SYDNEY CENTRAL CITY PLANNING PANEL

ADDENDUM REPORT (POST-MEETING)

Melrose Park Concept Plan and Stage 1 DA Assessment	
Panel Reference	2016SWC008
DA Number	DA/1157/2016
LGA	City of Parramatta
Proposed Development	<ul style="list-style-type: none">• Staged Concept Plan, pursuant to s83B of the Environmental Planning and Assessment Act 1979, for up to 1,077 dwellings and associated buildings and roads over 4 stages; and• Detailed Development Application for Stage 1 in the north-east corner of the site comprising superlot subdivision of the site; 277 units in 3 residential flat buildings, a 71sqm retail space, public open space area (the western plaza), associated basement parking, site works, and strata subdivision. <p>Amended DA lodged 13/06/2017 and 25/07/2017.</p>
Street Address	657 - 661 Victoria Road & 4 – 6 Wharf Road, MELROSE PARK NSW (Lots 2 & 3 DP588575, Lot 11 DP128907, Lots 1 & 2 DP221045, Lots 71 & 72 DP1136996, Lot 2 DP619396, Lots 1 & 2 DP128912)

Figure 1. Melrose Park Planning Proposal Masterplan showing subject site in red and NSR-2 corridor in blue. The proposed condition relates to the setback of the buildings shown in grey that adjoin the NSR-2 road reserve.

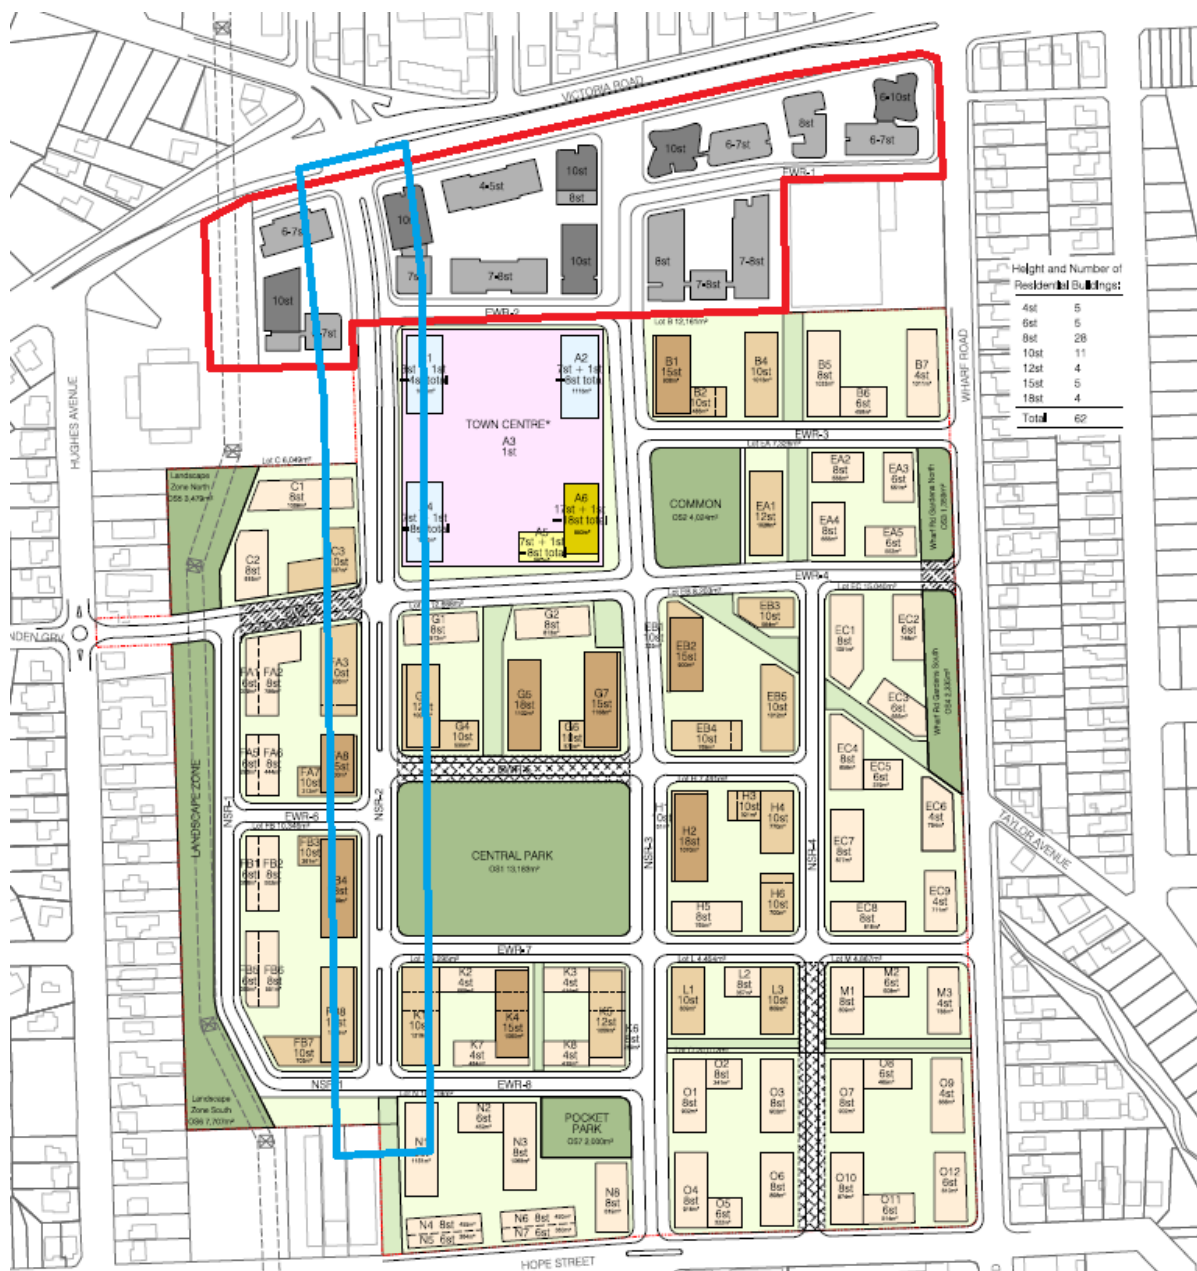
Notwithstanding the building envelopes outlined on the concept plans hereby approved, all buildings in future detailed applications must be setback a minimum of 5m from NSR-2 unless otherwise agreed by Council.

The applicant contends that the 3m setback outlined on the concept plan drawings is sufficient and have submitted a letter (see Attachment 2), with associated drawings, outlining their case. In summary, their justification for a 3m setback is as follows:

- *it is consistent with the proposed setbacks in the Masterplan for the adjoining development to the south of the site, which is part of the adopted Planning Proposal for Melrose Park adopted by Council and subject to a favourable Gateway Determination*
- *it maintains sightlines on the main boulevards*
- *it provides for good pedestrian amenity*
- *is consistent with the relevant DCP control (for both the existing B4 Mixed use zone and proposed B2 Local Centre zone to the south)*

The 5m setback to NSR-2 is considered to be necessary for the following reasons.

The draft master plan for the northern part of Melrose Park is still being finalised although high density development is anticipated to occur across the site (as outlined in Figure 1 above). Although the subject site has an existing B4 Mixed Use zone and is not subject to the master plan, any development that occurs at this location will influence future development on land in the remainder of the northern precinct.

Advice received from Council's Urban Design team during the preparation of the master plan for the remainder of the northern precinct specifies a setback requirement of 5m given the scale of the proposed development and need to provide a desirable streetscape for NSR-2, the main thoroughfare through the wider site. To ensure a consistent, strategic approach is applied to the Melrose Park precinct it is recommended that the same 5m building setback also be applied to the proposed development given its comparable scale and connection to the remainder of the precinct.

The current 3m building setback requirement for development in the B4 Mixed Use zone is not considered appropriate for the proposed development and should be varied to 5m to enable a holistic approach to be taken for the precinct. The 3m setback is a generic control that was written with the intention of applying it to smaller-scale developments across various B4 Mixed Use zones throughout the LGA and at the time, there were no large-scale urban renewal precincts such as Melrose Park within the LGA that would require a greater setback to be considered.

As outlined above the requirement to provide a minimum 5m setback to NSR-2 is considered to be appropriate as this road will form the primary north-south link off Victoria Road for a new suburb.
